Please find the attached objection in regards to Ref – FW.7.21 Port of Waterford Company – Dumping at Sea Permit at Waterford Harbour
EPA Ref – S0012 - 04

Ref – FW.7.21 Port of Waterford Company – Dumping at Sea Permit at Waterford Harbour

EPA Ref – S0012 - 04

Figure 8: Aerial view of proposed development projects for review

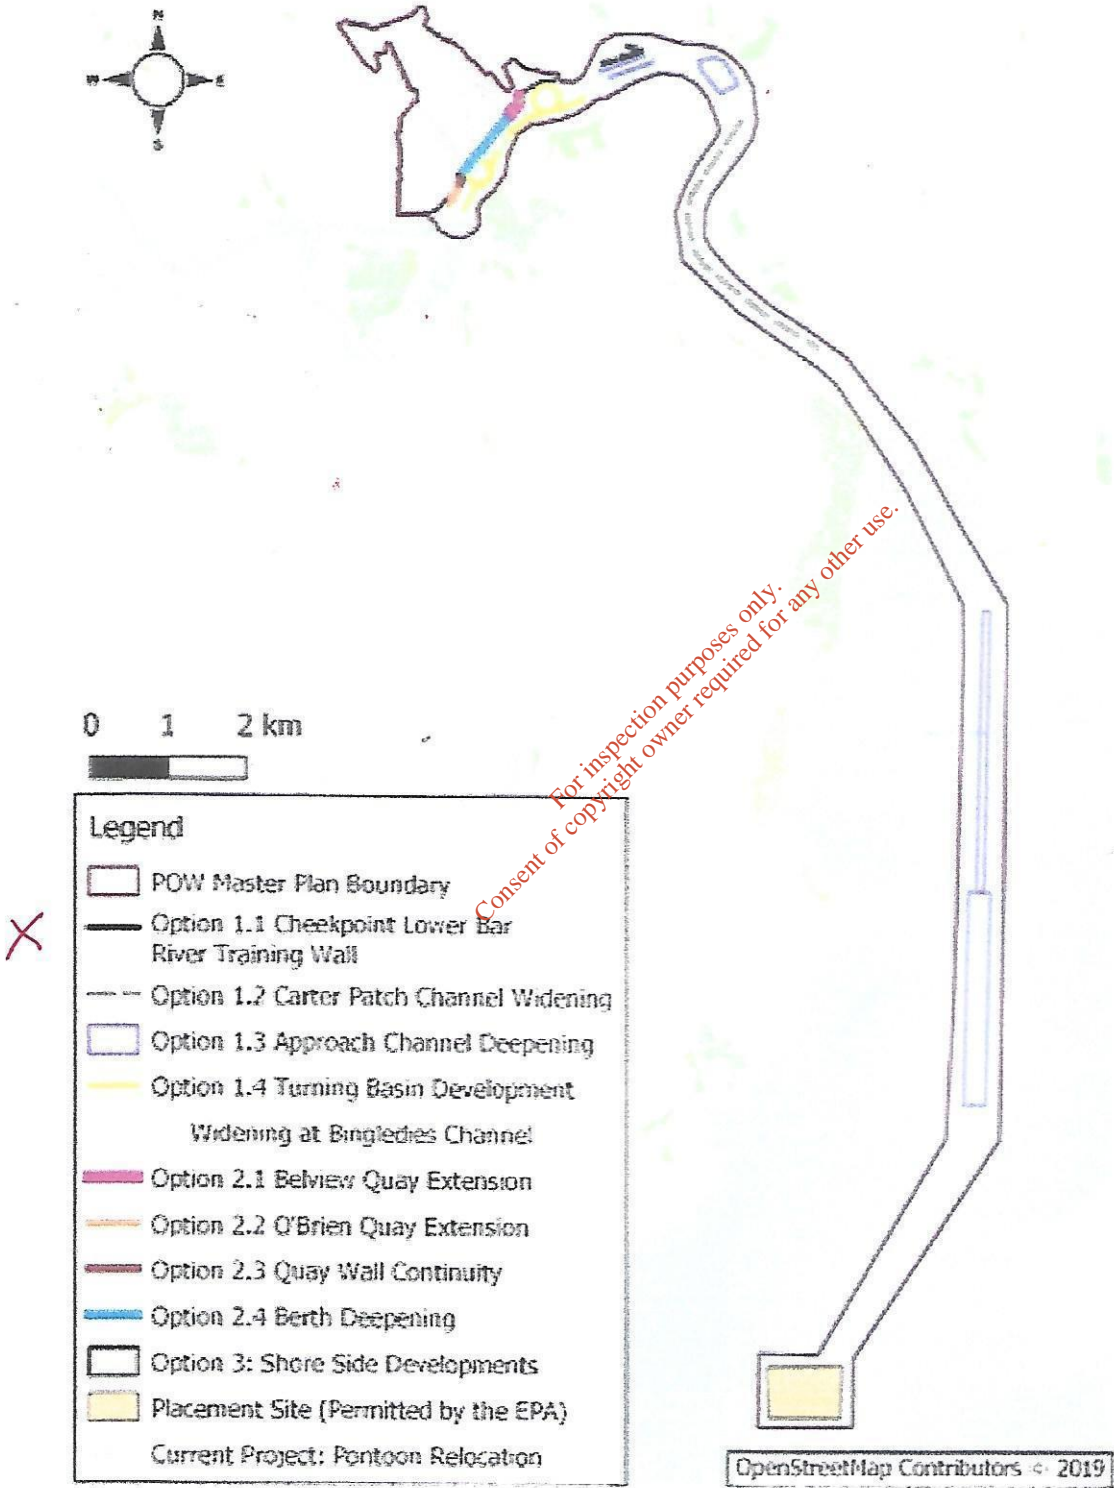
Where does the Dredging and Dumping at Cheekpoint Lower Bar fit in to the Port of Waterford's Master Plan 2020/2044 ?In the plan a river training wall is proposed for that area. See attached pages.

**Evidence of Changes to Marine Environment
(Shellfish Dieback) at Cheekpoint**

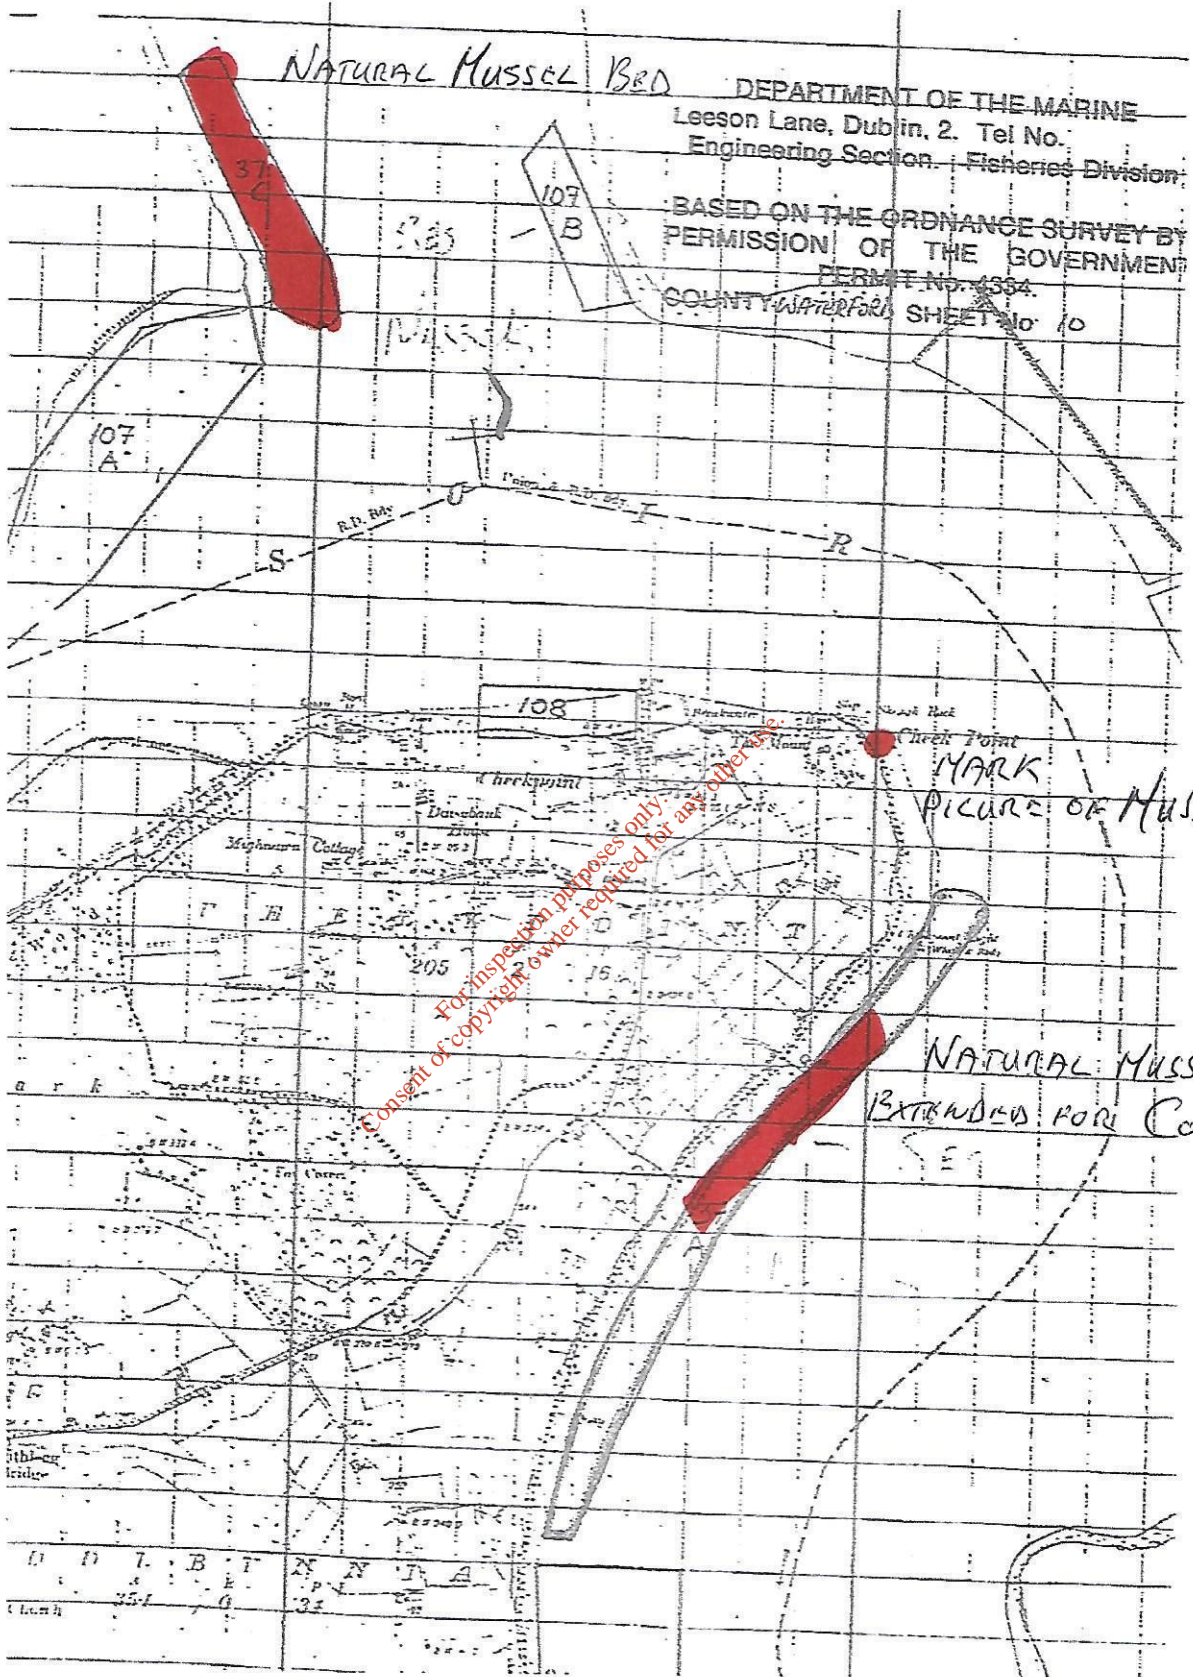
See attached additional information for positions of naturally occurring Mussel beds along with position of Cheekpoint mark with Mussels in 2015 as it should and how they should not be 2020.

2016 ← MUSSELS.

2020 NO MUSSELS W.
